CITY OF BEVERLY

RE: INVITATION FOR BIDS # 24-037 Commercial Marina Hoist Pier Replacement Project

This addendum contains six (6) pages, and forms a part of the Invitation for Bids from the City of Beverly for # 24-037 Commercial Marina Hoist Pier Replacement Project.

E DAVIT CRANE DETAIL
06 SCALE: 1" = 1'

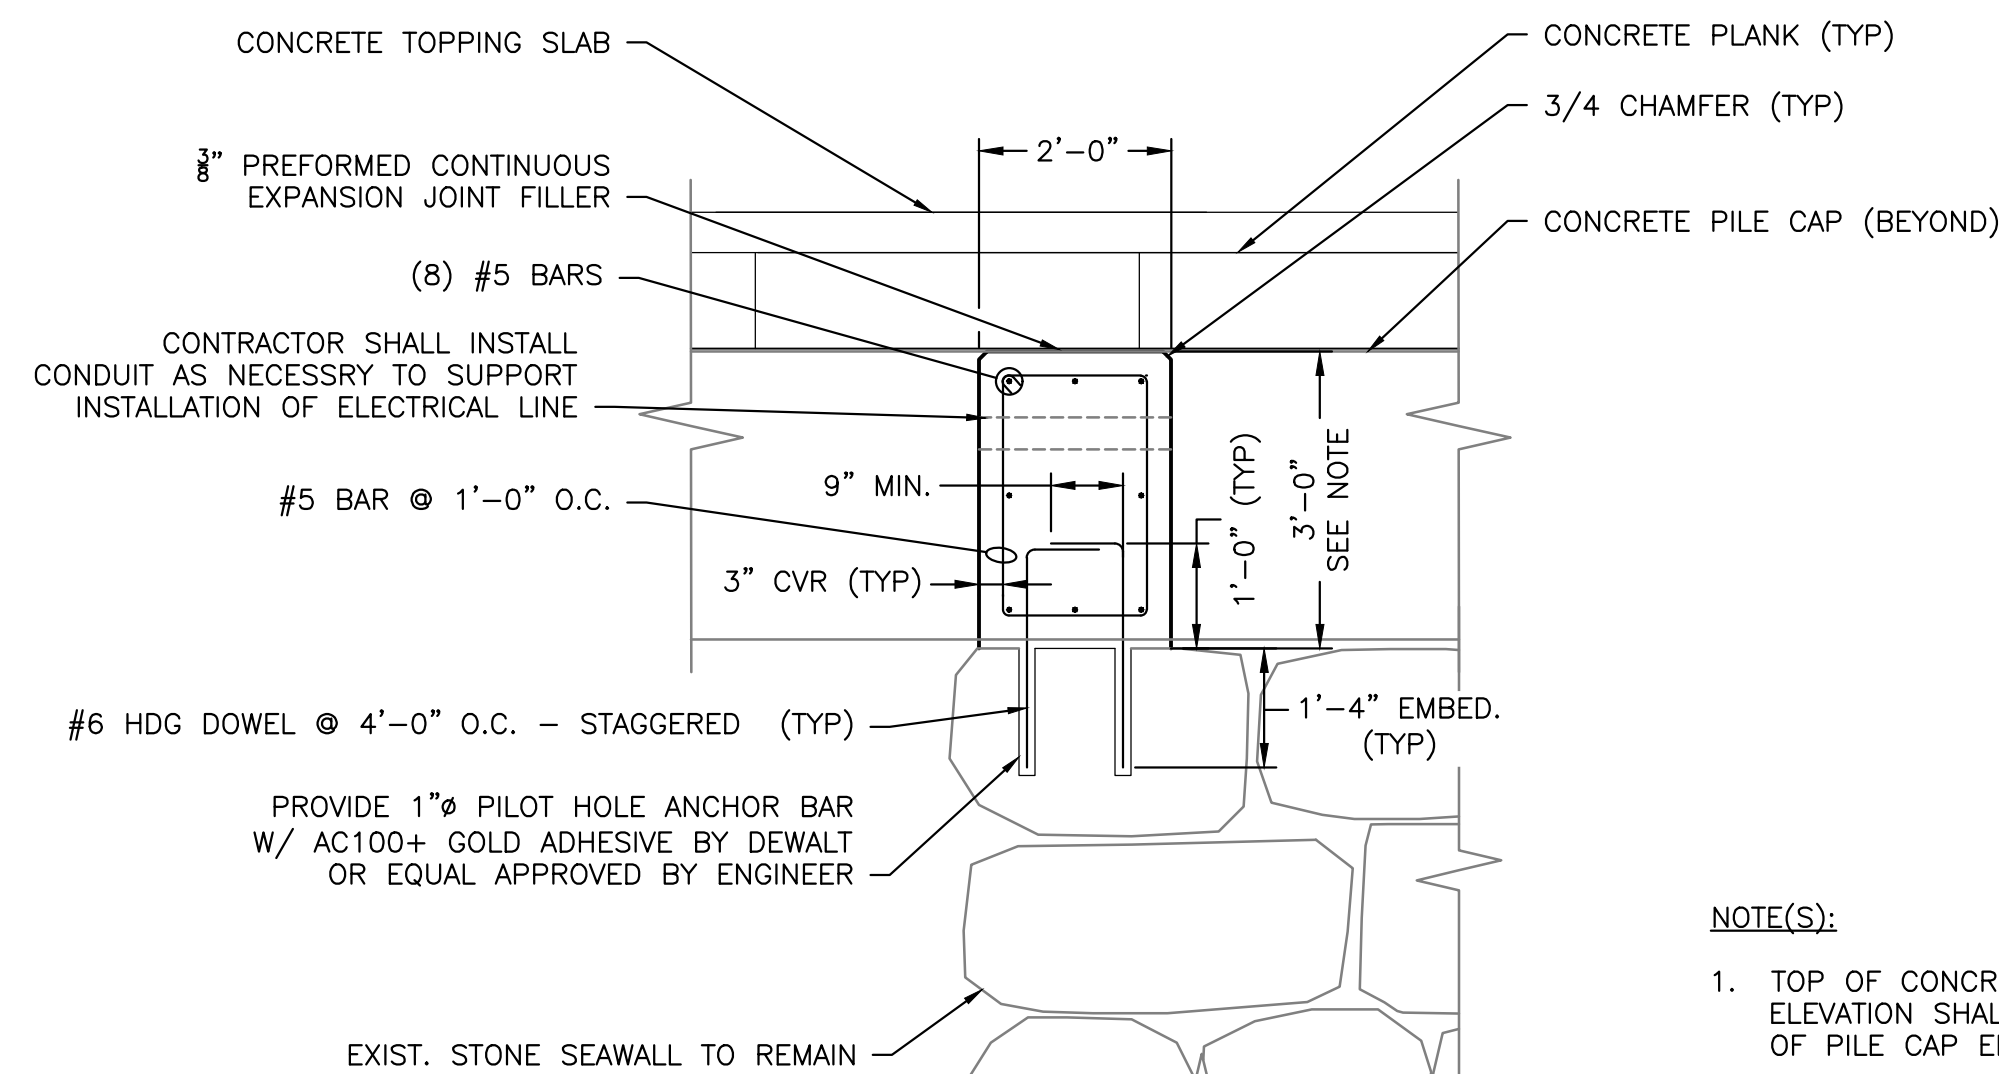
Question 3: *“Please confirm required dimensions of the davit crane.”*

Question 7: *“Please provide anchor bolt requirements for new davit crane.”*

Response 3: The davit crane shall have a 12-foot boom length. The bottom of the boom shall be 13.5 feet above the concrete deck of the hoist pier.

Response 7: The Davit Crane Detail is shown on Contract Drawing Sheet 8, which is included as an attachment to this Addendum.

F CONCRETE SEAWALL DETAIL
07 SCALE: 1" = 2'

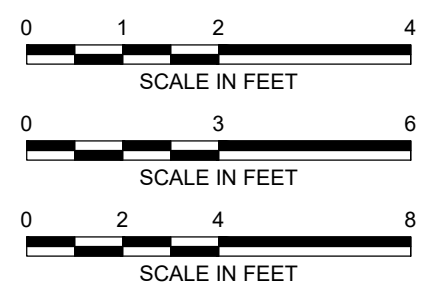
Question 9: *“Please provide a detail for the concrete seawall construction.”*

Response 9: The detail for this is shown on Contract Drawing Sheet 8, which is included as an attachment to this Addendum.

ROCK SOCKET DETAIL
 SCALE: N.T.S.

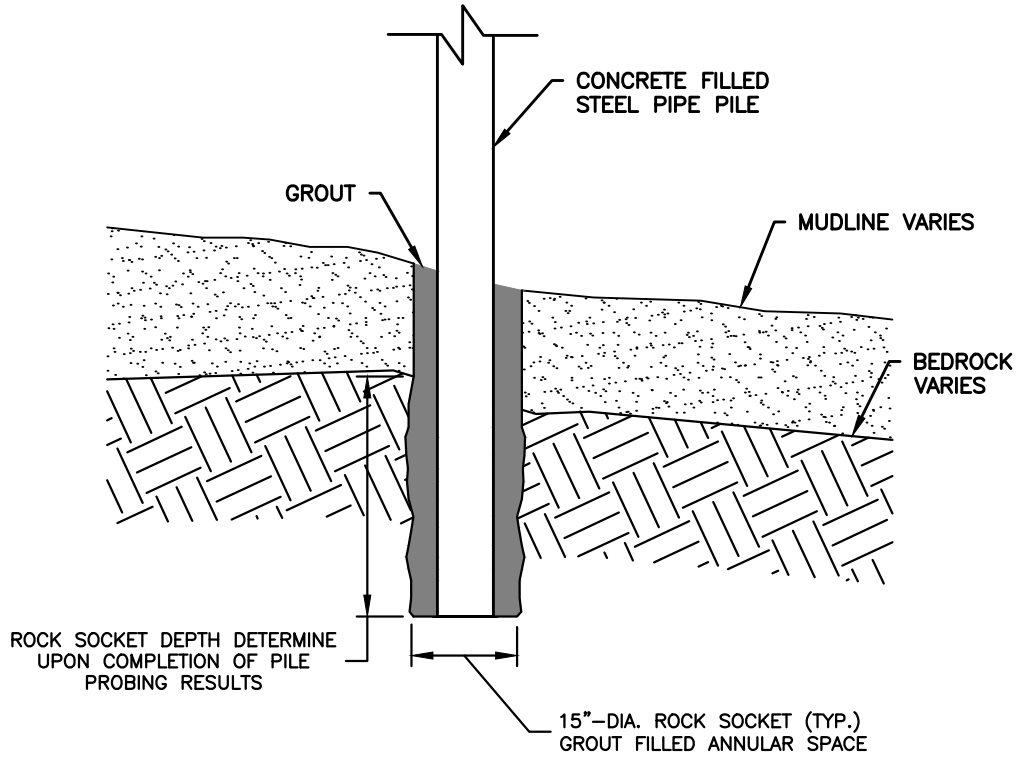
Question 2: *“Please confirm if there are any details for the rock sockets.”*

Response 2: Rock sockets shall be a minimum 15-inches in diameter. A Rock Socket Detail is included as an attachment to this Addendum.
